ADDENDUM NO. 1 - OUTLINE AND SUMMARY INFORMATION

Project Name: BART Farm Nutrition Center Roof Replacement PPA No.: 18-2101
Date: 3/14/19

Project Name: BART Farm Nutrition Center Roof Replacement PPA No.: 18-2101 (A118 18-041)
Location: Montana State University Date: March 14, 2019
Owner: State of Montana
Montana State University
Bozeman, Montana

1 ROOF PLAN
 SCALE: 1/8" = 1'-0"

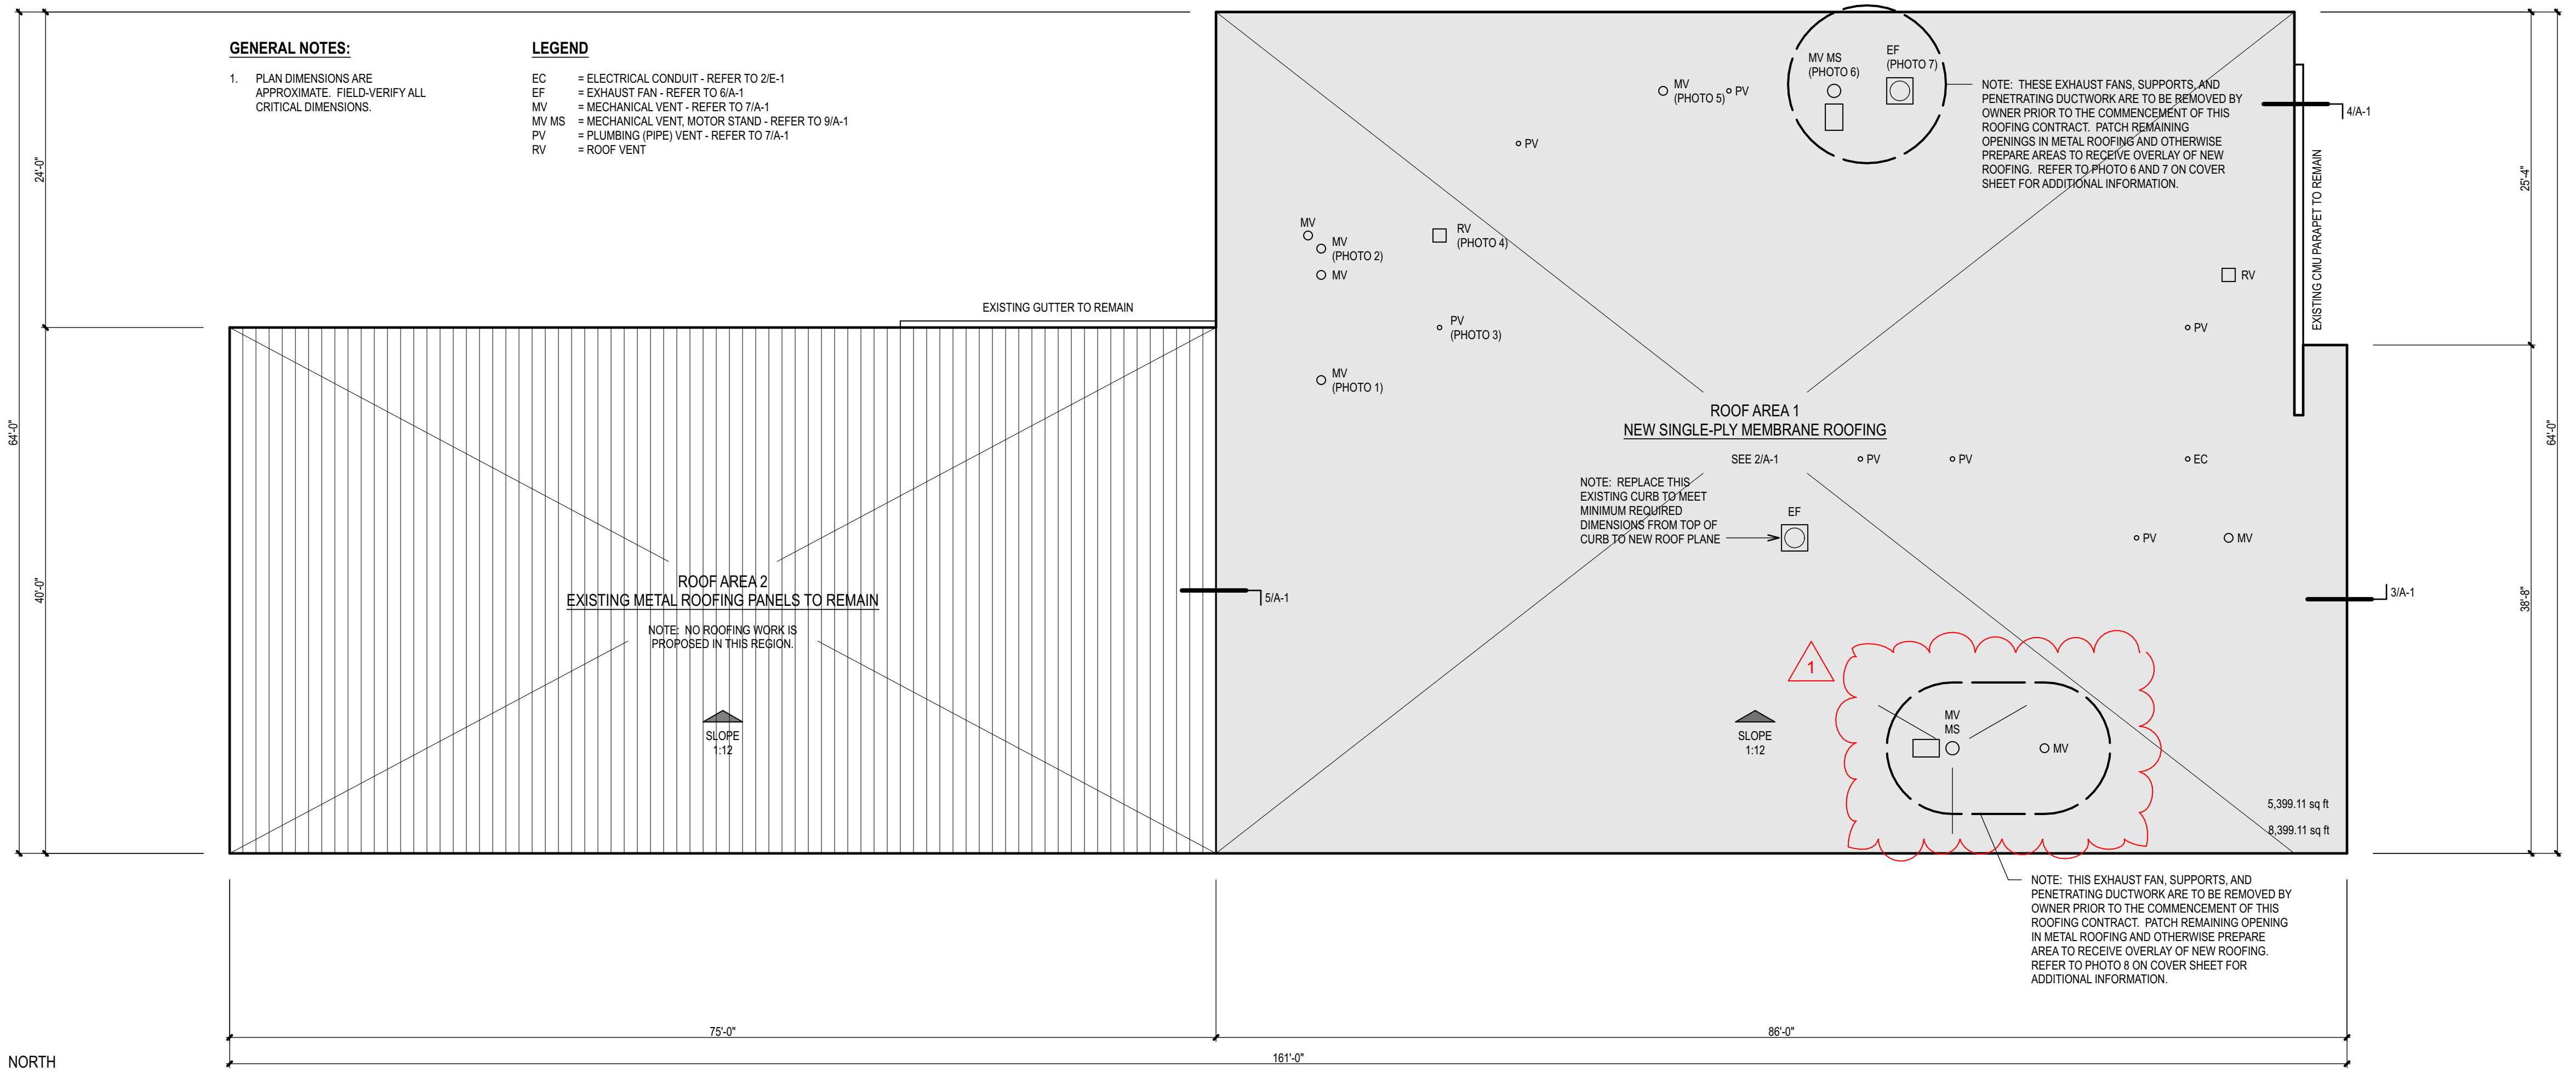
- A. Sheet SPEC-2, Section 075323 (EPDM Roofing)
- B. Sheet A-1, Drawing 1 (Roof Plan)
